Subject: Borel Middle School HVAC Replacement
San Mateo - Foster City School District
Aedis Project No. 2021005
DSA Application #01-119557

ADDENDUM NO. 1

SHEET # AD1-
MP6.02

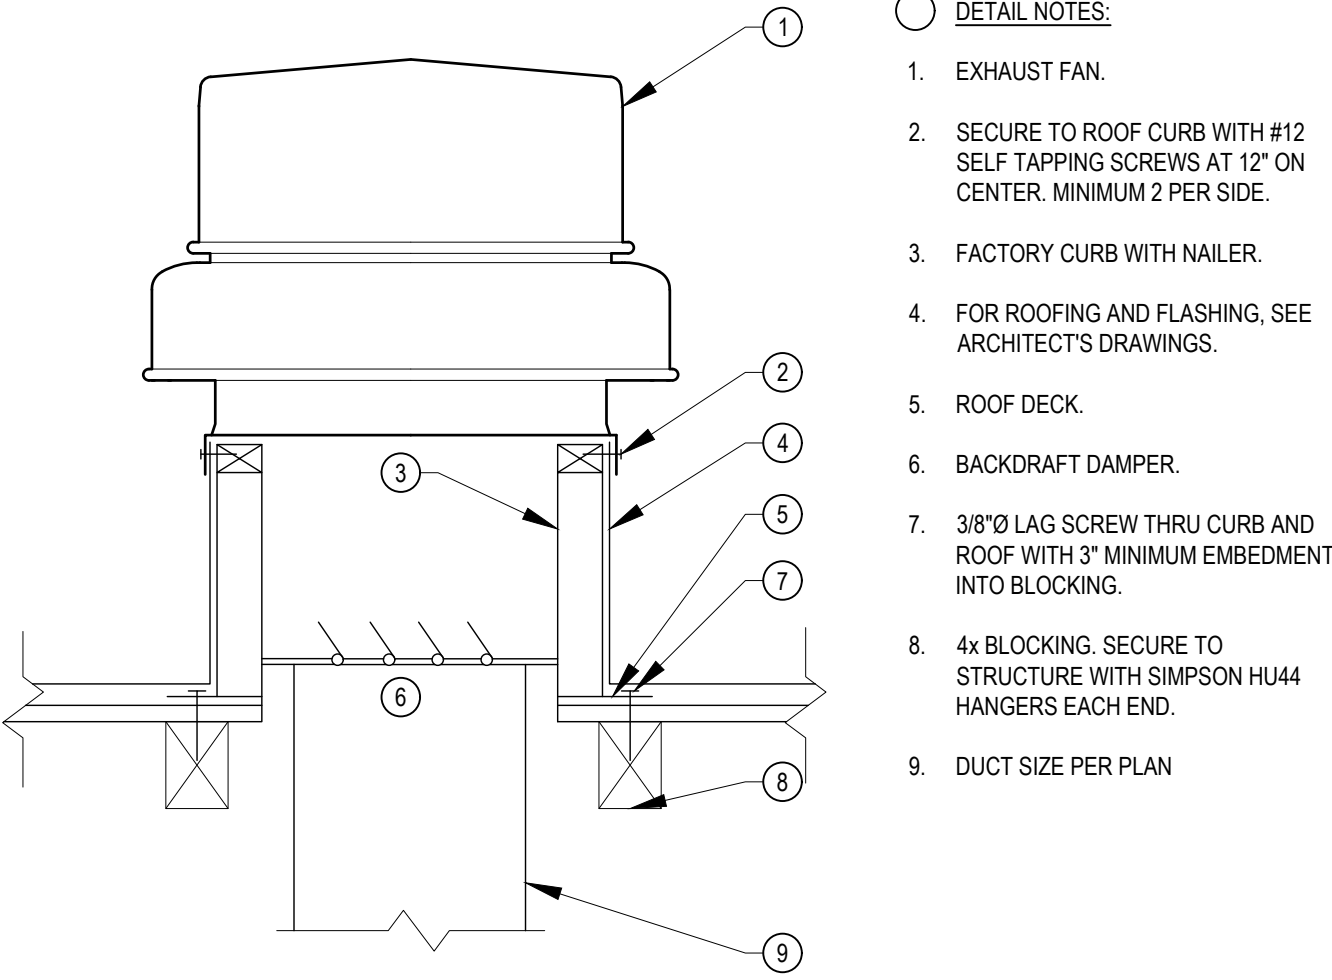
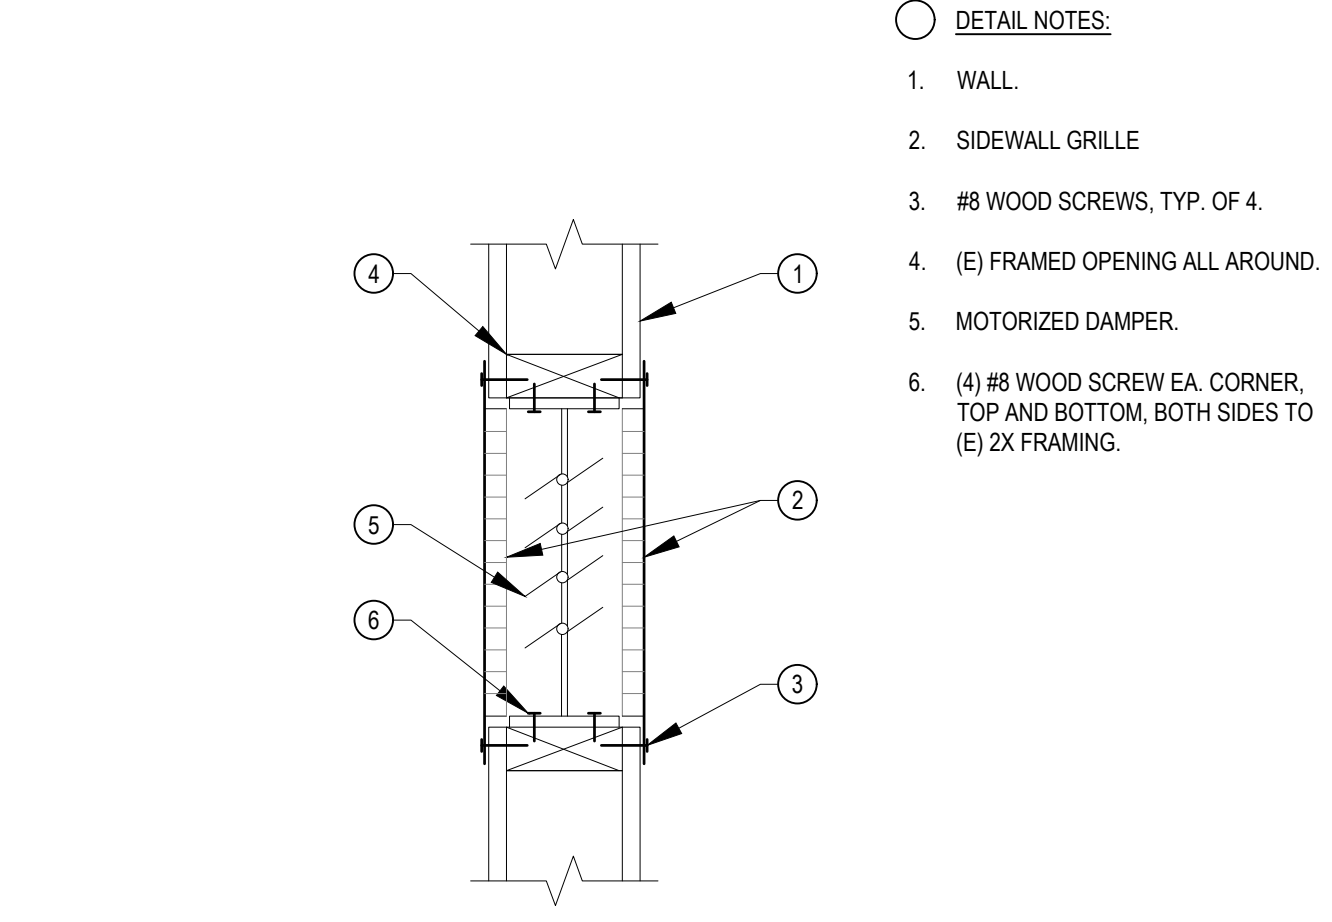
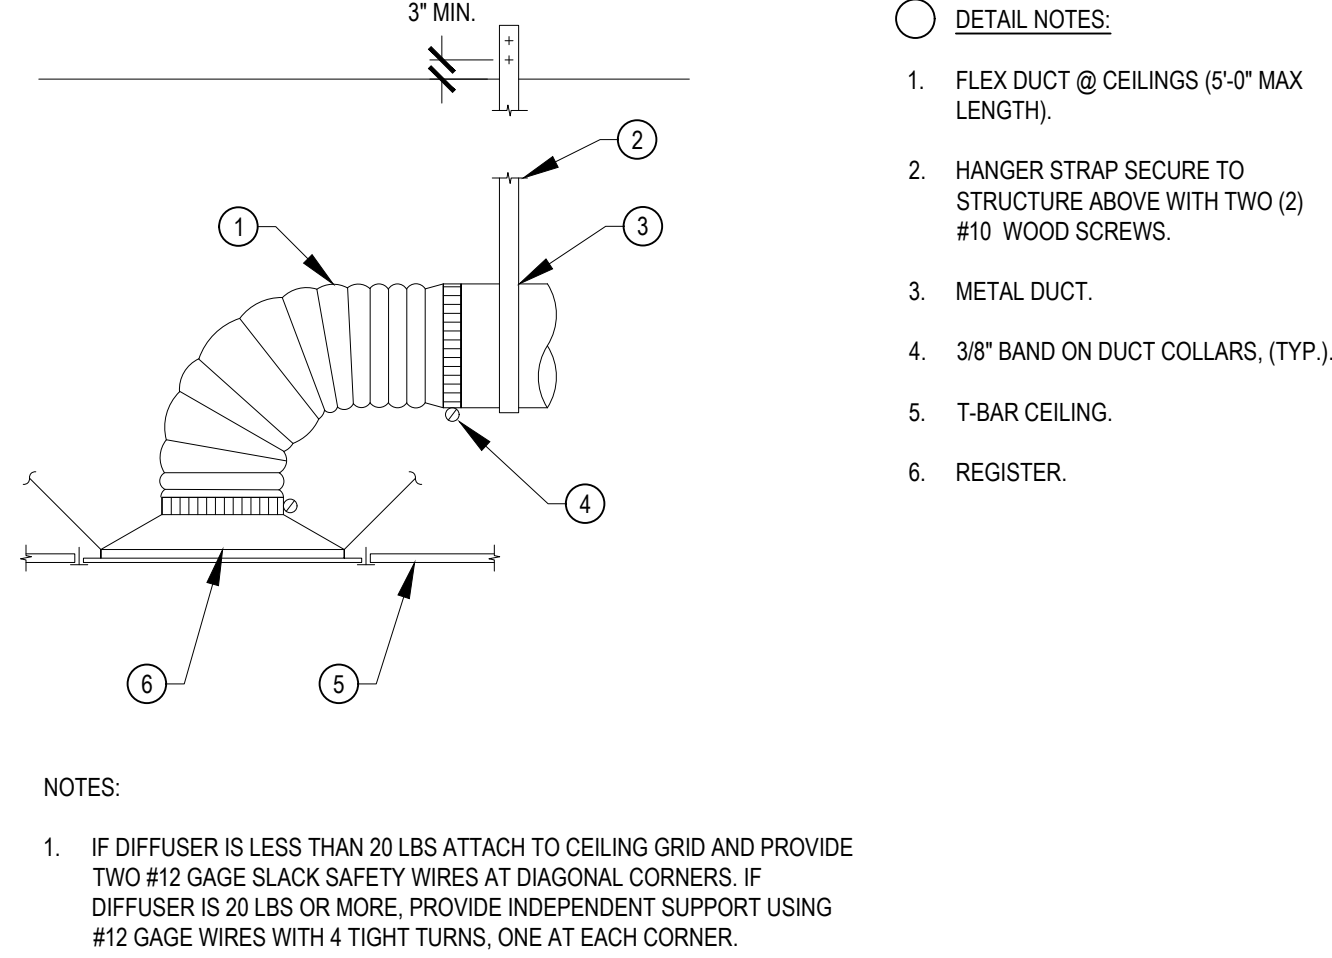
Add: New sheet in its entirety per AD1-MP6.02

ELECTRICAL SITE PLAN

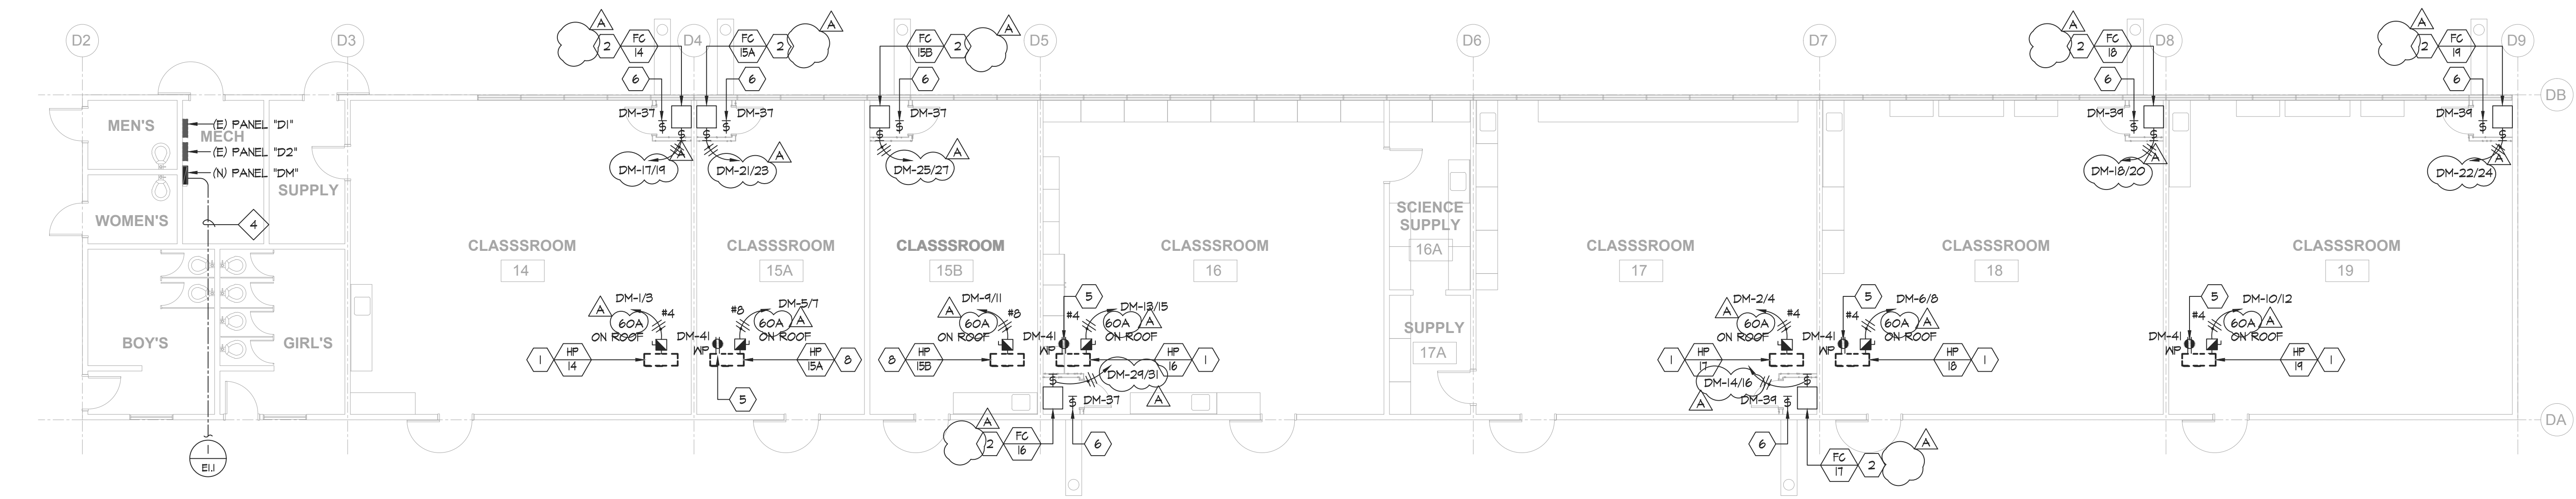
Add: In-grade pull box adjacent to existing switch gear per AD1-E1.1

**ELECTRICAL NEW
FLOOR PLANS -
BLDGS A, B, C & D**

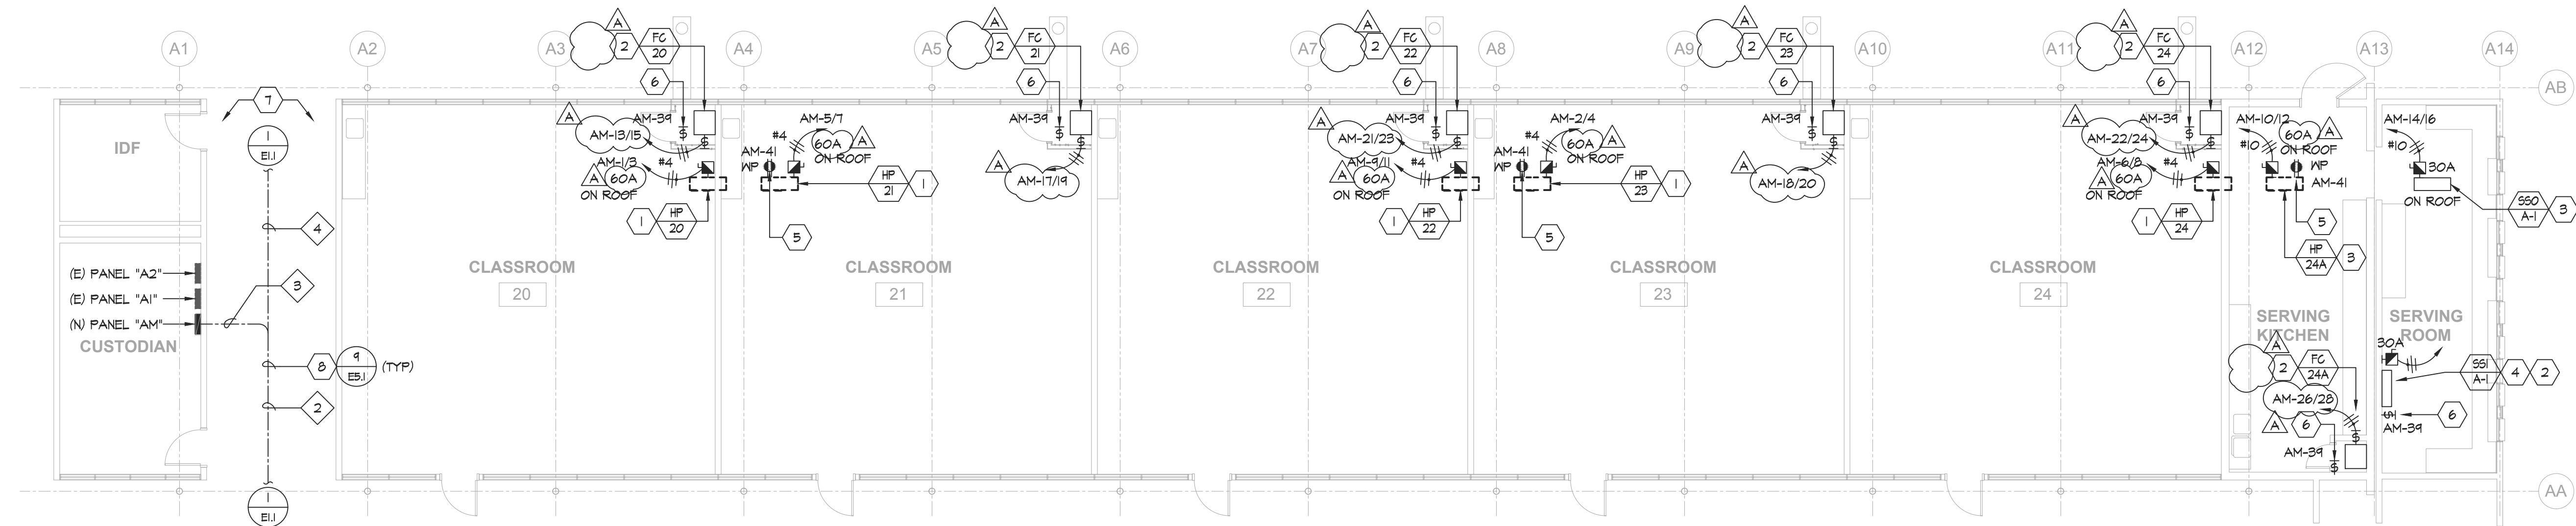
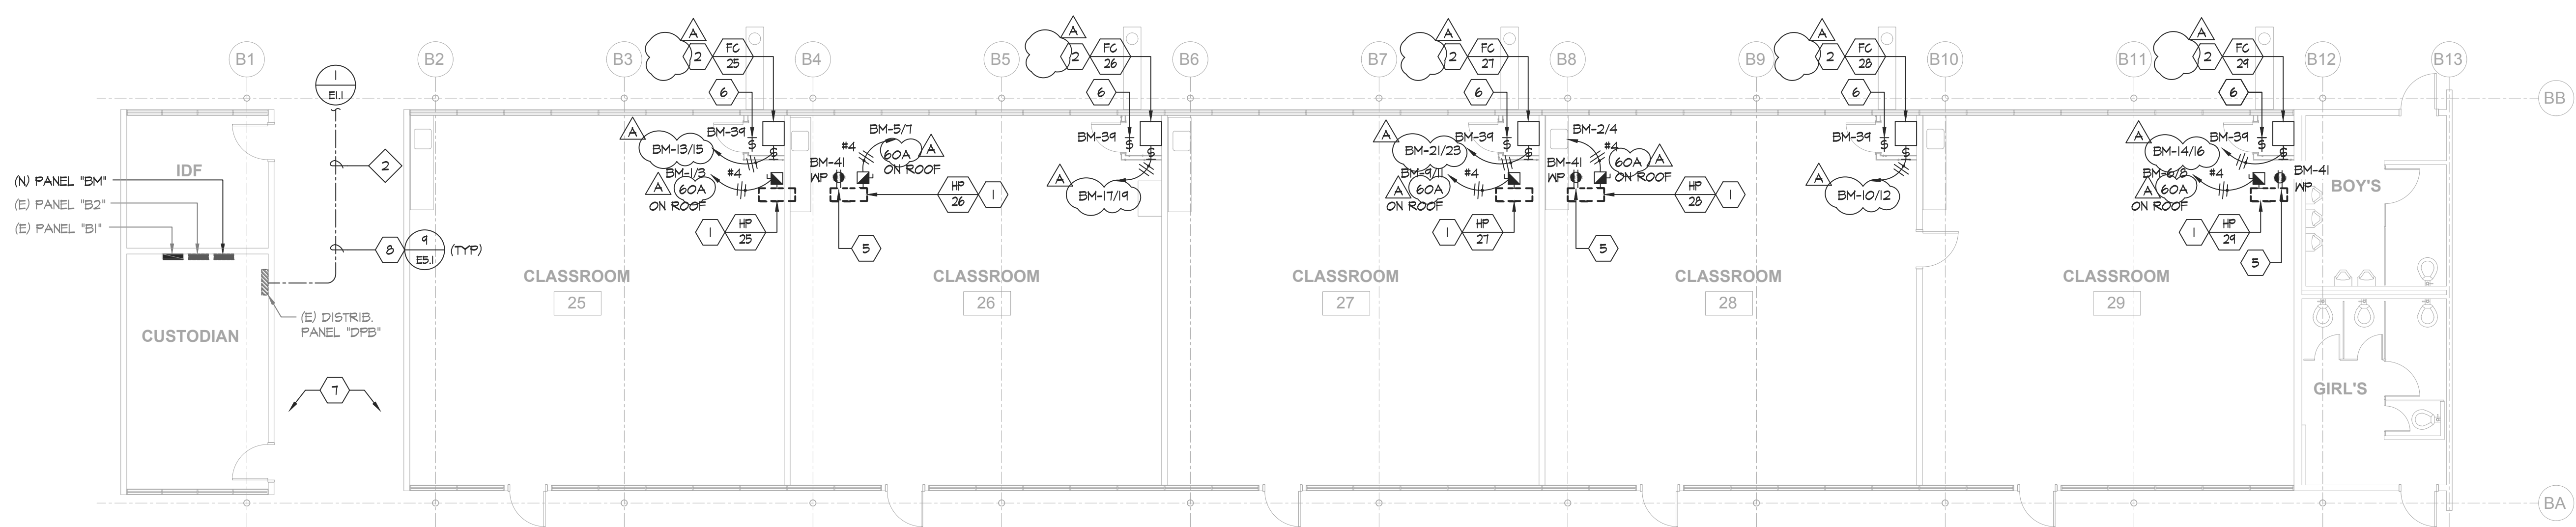
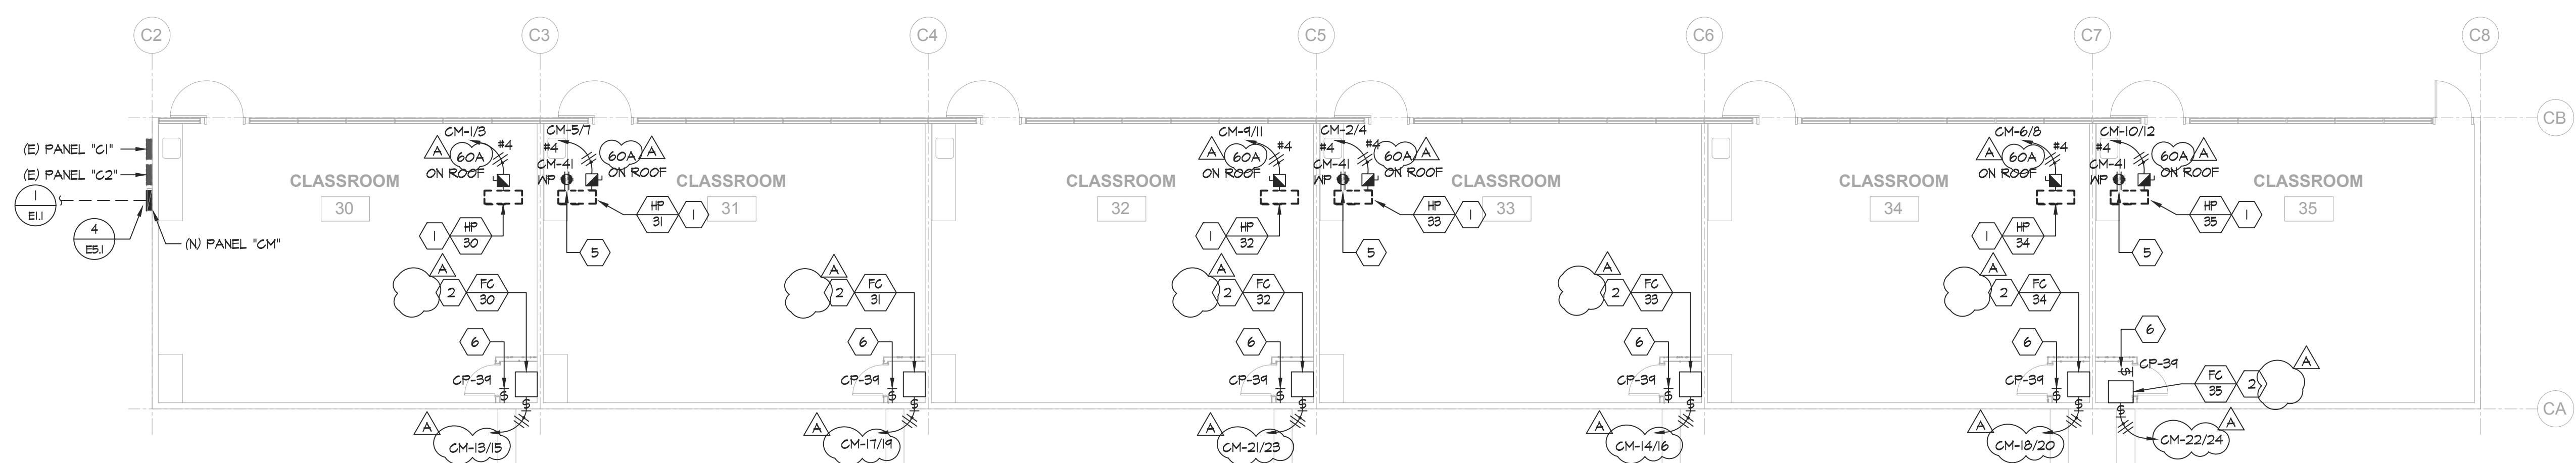
Add: General Notes #6, as shown clouded on AD1-E3.1

Revise: Electrical plans 1/E3.1, 2/E3.1, 3/E3.1 & 4/E3.1 per AD1-E3.1
